Proj. No.: SUR2201

Subject: Addendum No. 1
Surf City WWTF Digester/Sludge Holding Tank
Surf City, NC
Owner: Town of Surf City

ADDENDUM NO. 1

4 WASTE SLUDGE CONNECTION

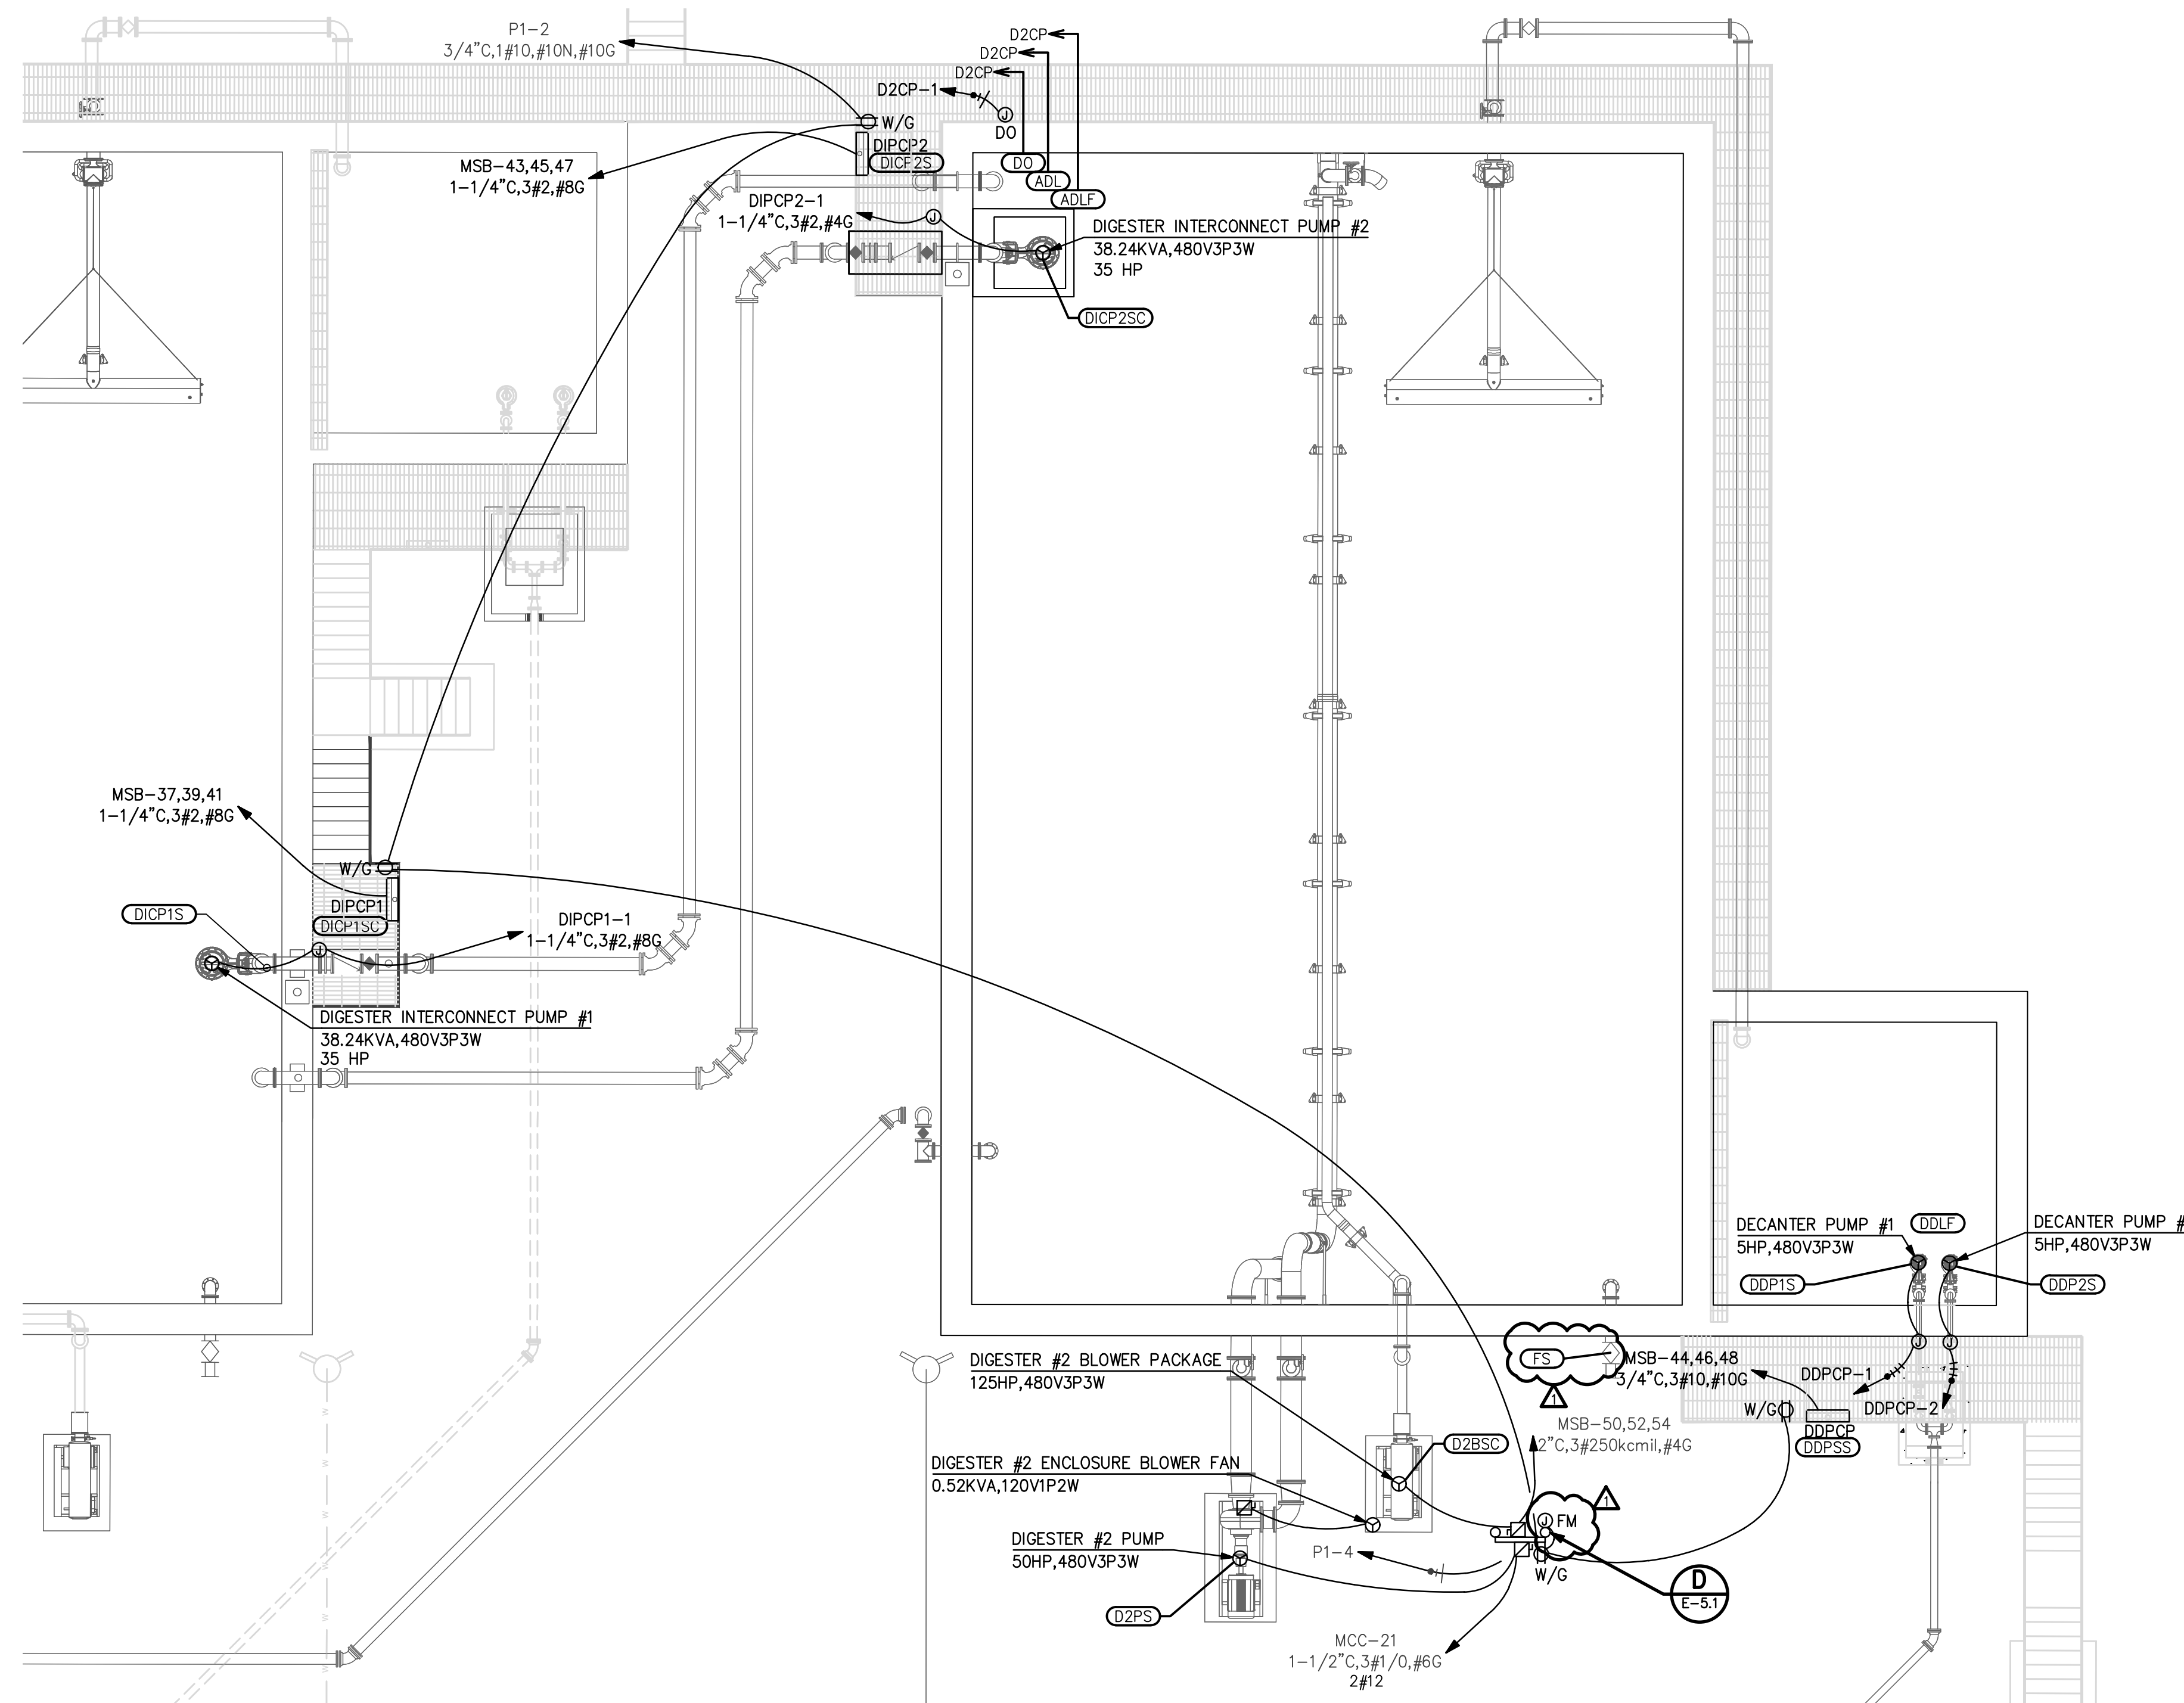
- Item 1.22:** Can a section view of the 8" Sludge Waste piping at elev 38.77 be provided to better detail the pipe/fittings/and valves required? It is shown in Plan View on Drawing C-1.4 but we are not able to locate a section view.

- **Refer to the attached detail for the waste sludge connection. Sheet C-1.4 will be revised to show a waste sludge connection centerline. Power shall be provided to flow meter as shown in revised Sheet E-0.1 and Sheet E-1.2 attached.**

1. ELECTRONIC FLOW METER SHALL BE SIEMENS SITRANS F M MAG 5100 W, OR EQUAL.
2. MOUNT WIRED SITRANS F M MAG 5000 TRANSMITTER, OR EQUAL, ADJACENT TO WASTE SLUDGE CONNECTION.
3. PROVIDE WALL MOUNTED SS WEATHER HOOD TO PROTECT TRANSMITTER FROM THE ELEMENTS
